*BEACON PLANNING BOARD*  
*One Municipal Plaza - Courtroom*  
*BEACON, NEW YORK 12508*  
*Phone (845) 838-5002 Fax (845) 838-5026*

The Planning Board will meet on **Tuesday, December 12, 2017** in the Municipal Center Courtroom. A work session will take place at 7:00 PM for a training workshop, discussion of agenda items and/or topics of interest to the Planning Board. The regular meeting will begin immediately thereafter, but not later than 7:30 p.m.

**Edgewater**

**Re: Edgewater – 22 Edgewater Place, Beacon, New York**  
*Site Plan Application – Responses to Comments*

**Site Lighting Plan**  
Sheet 4 of 15  
**Edgewater**  
Beacon, New York  
Scale: 1" = 40'  
January 31, 2017

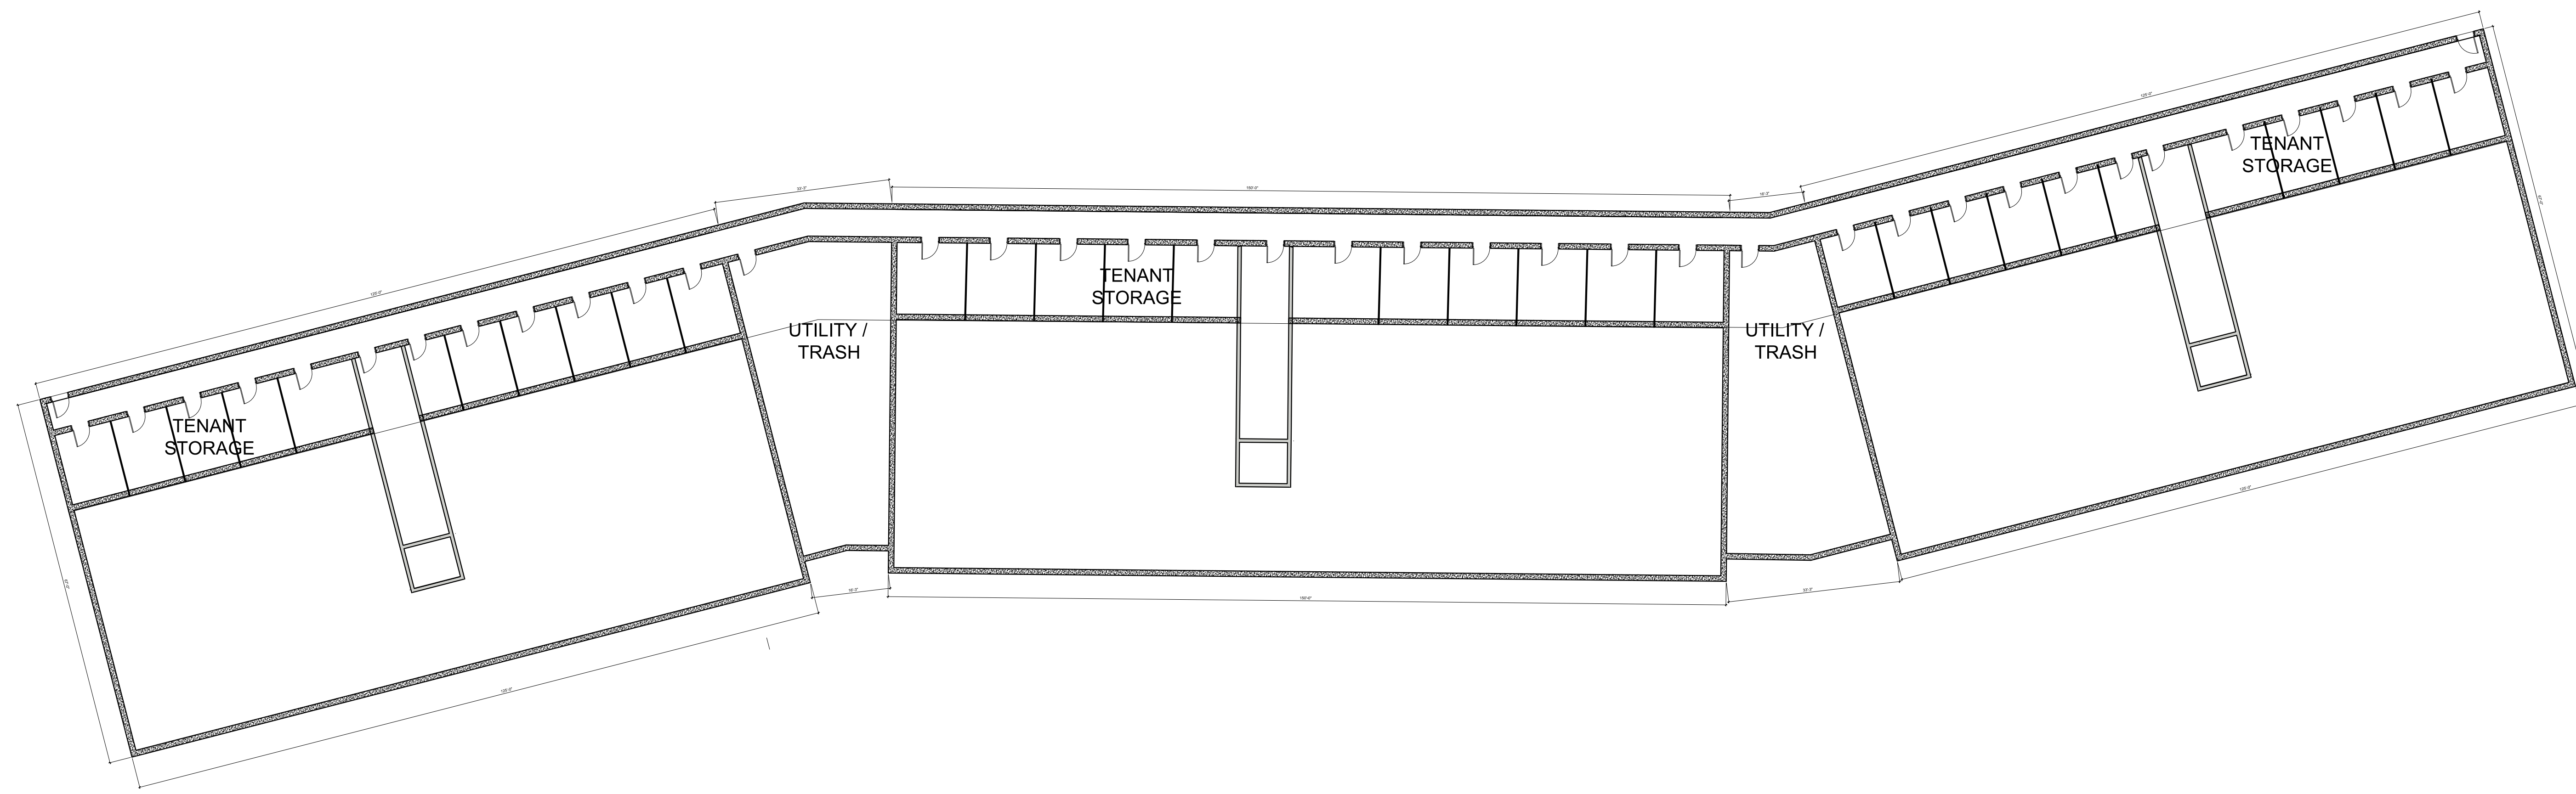
On behalf of the Applicant for the above referenced project, Hudson Land Design (HLD) has not revised the plan set in response to Lanc & Tully's November 9, 2017 comment letter, and John Clarke Planning and Design comment memorandum dated November 9, 2017 at this time. We are scheduled to meet with the planning board's consultants on Wednesday, November 29<sup>th</sup> to discuss the re-alignment Branch Street in order to avoid conflict with adjacent properties and utilities in the area. Much of the final engineering comments will be slightly affected by re-alignment of Branch Street, so once a re-alignment location is determined at the meeting, the final engineering comments will be addressed. Aryeh Siegel has provided responses to Lanc & Tully's comment letter, and Mr. Clarke's memorandum, and has provided a partial plan set. The CD includes all sheets of the plan set including sheets that have not changed.
